REZN-24-18

Rezoning Feedback Letter

Jamestown Quarry Specific Implementation Plan

1 WEST PROPERTY LINE - AREA A
SCALE: 1"=30'

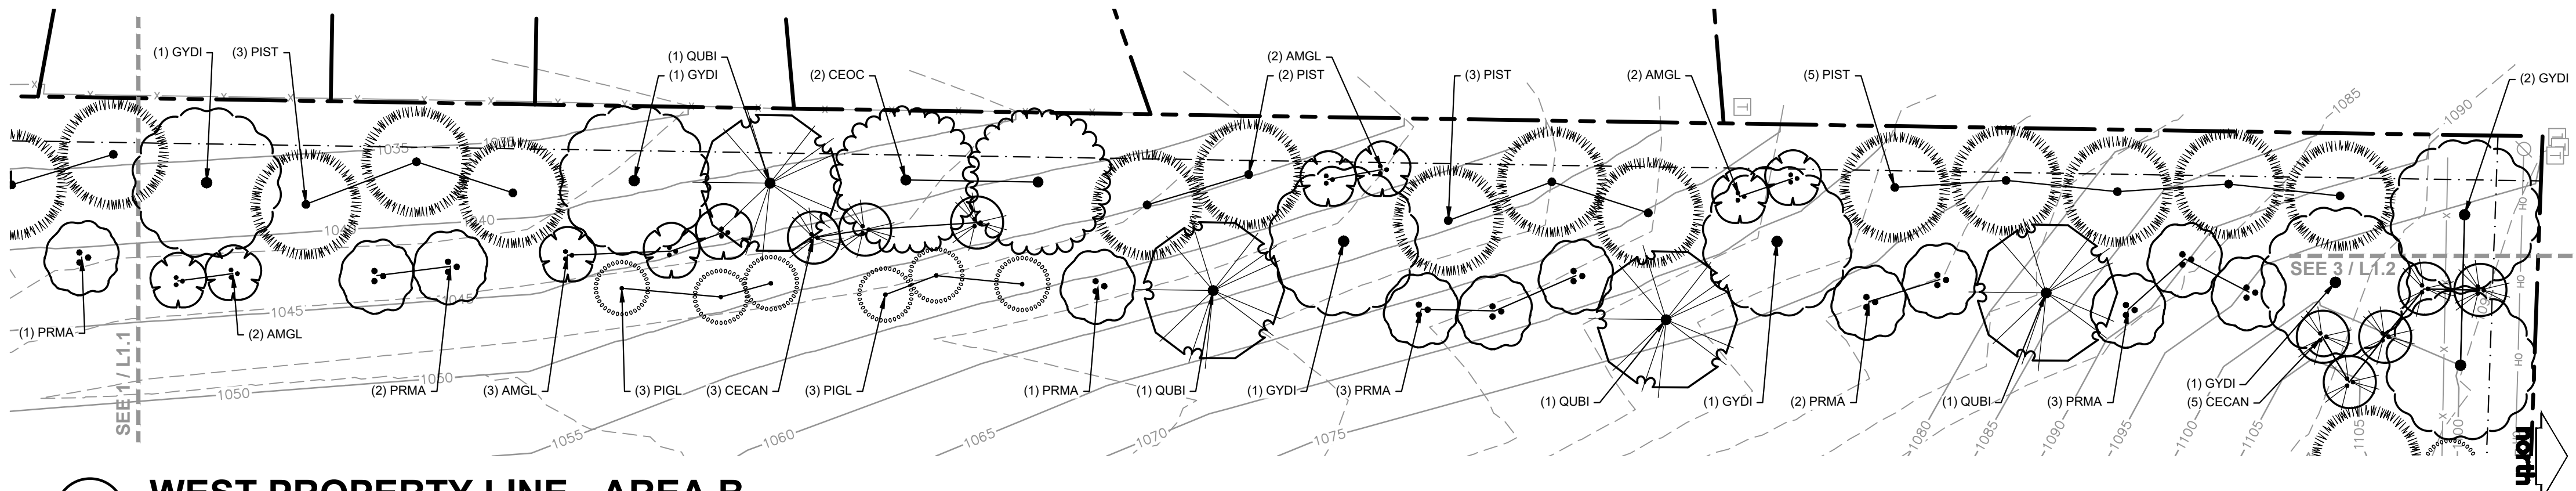
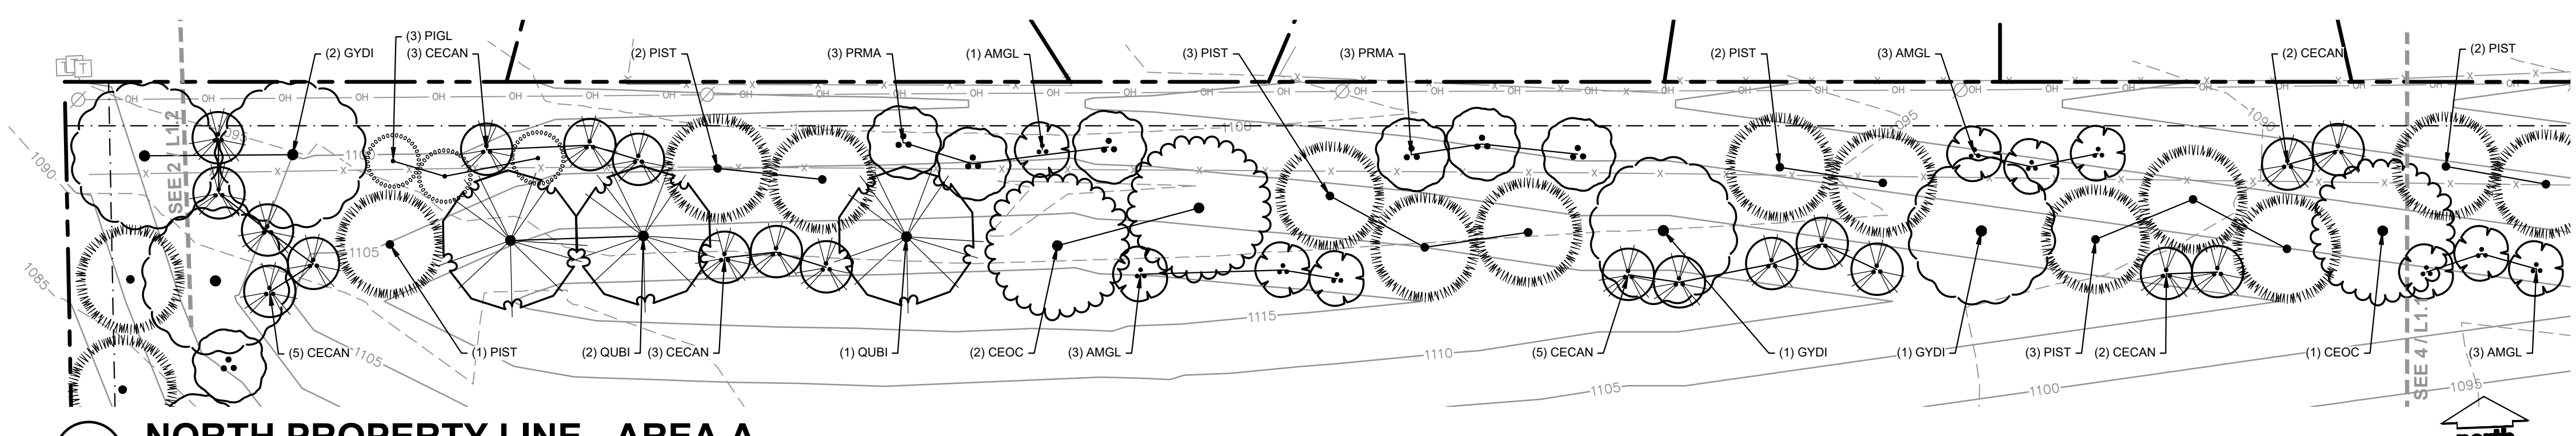
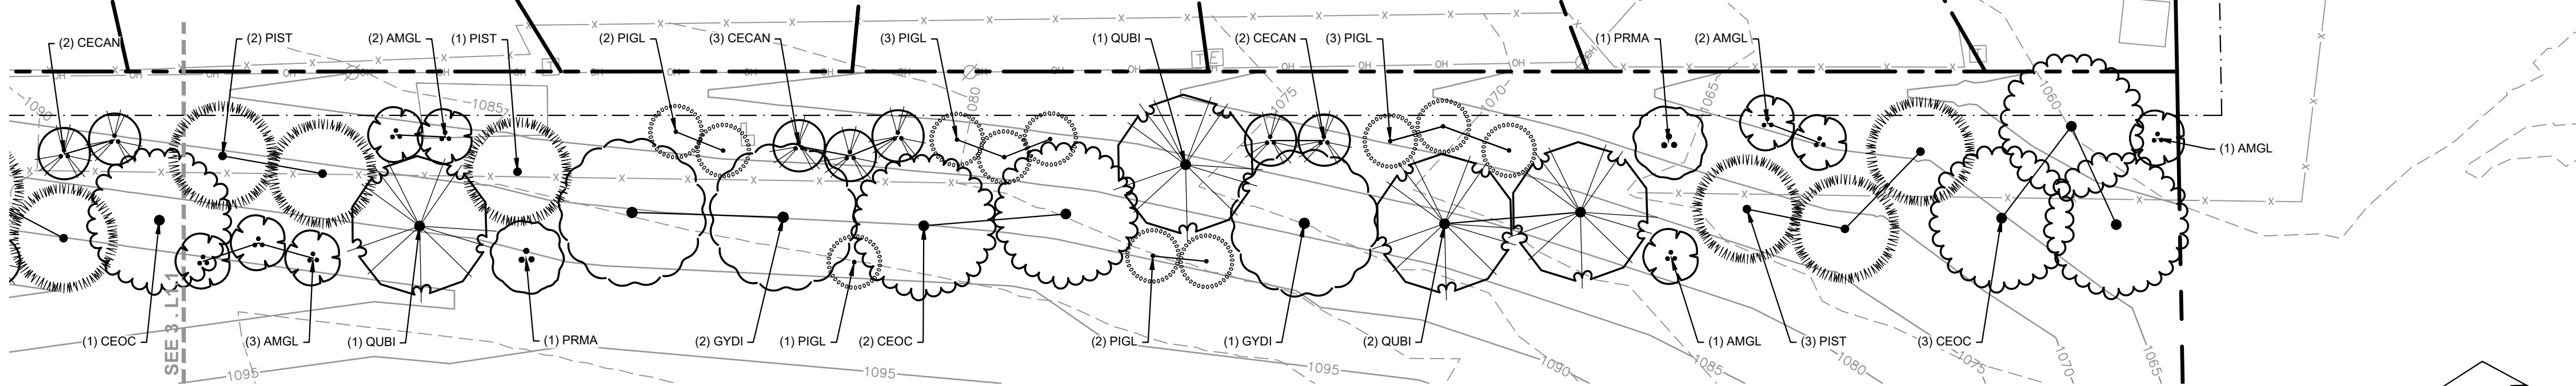
- c. The plans need to include fencing along the west and north property lines: wood screen fencing similar to that proposed for the multifamily development.

- 1. We understand further coordination on this item is in process between City departments and we will coordinate as needed.
- d. When will the plantings and fencing be installed at the west and north property lines? At a minimum the plantings and fencing must be installed prior to occupancy of the commercial lots.

EAST ELEVATION - FITCHRONA RD

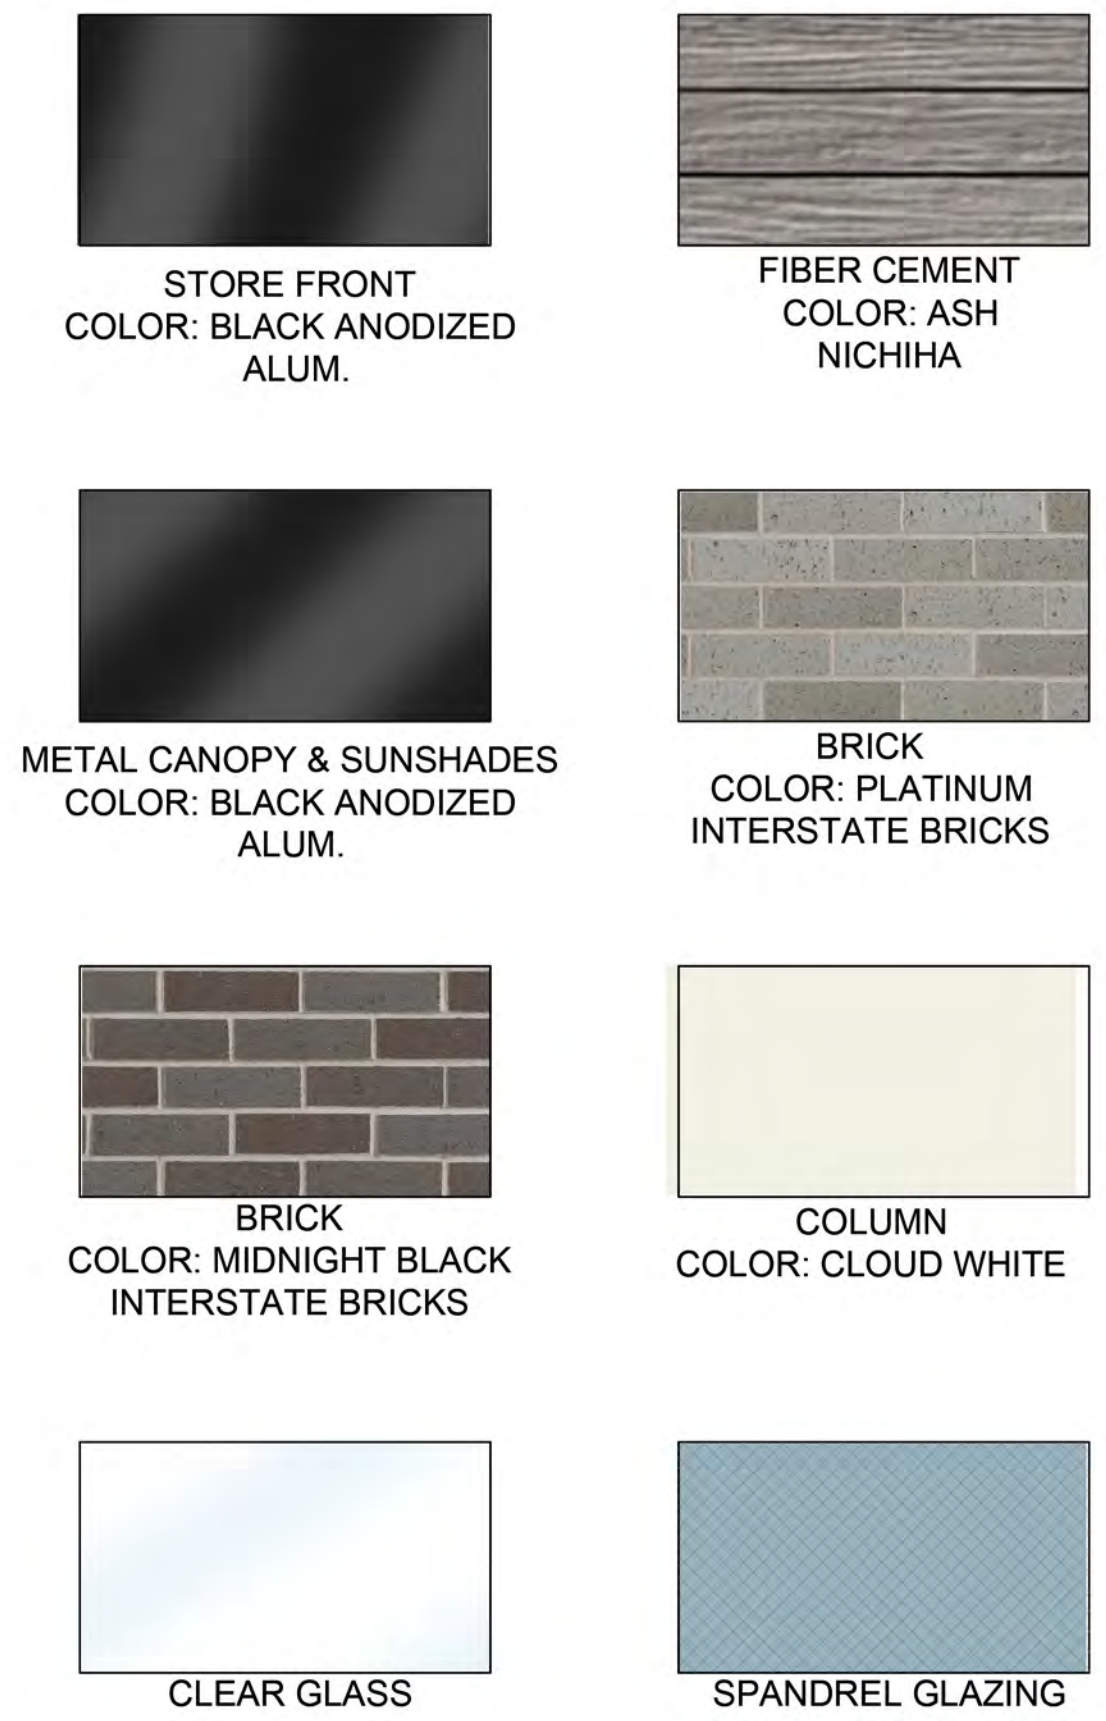
8. What can be done to the bank on the engage the facade with public view in a more urban form as seen from McKee and Fitchrona roads? We met with Chase and I expected a revision to the proposed plans. The ease elevation appears to leave roof top equipment exposed. Additional height is needed for this building similar to the Taco Bell across the street.

- a. As part of the revisions mentioned in the previous comment, wing walls will be incorporated to address any visibility concerns as it relates to exposed roof top equipment and to cut down on the amount of white TPO visible along the McKee and Fitchrona facades.
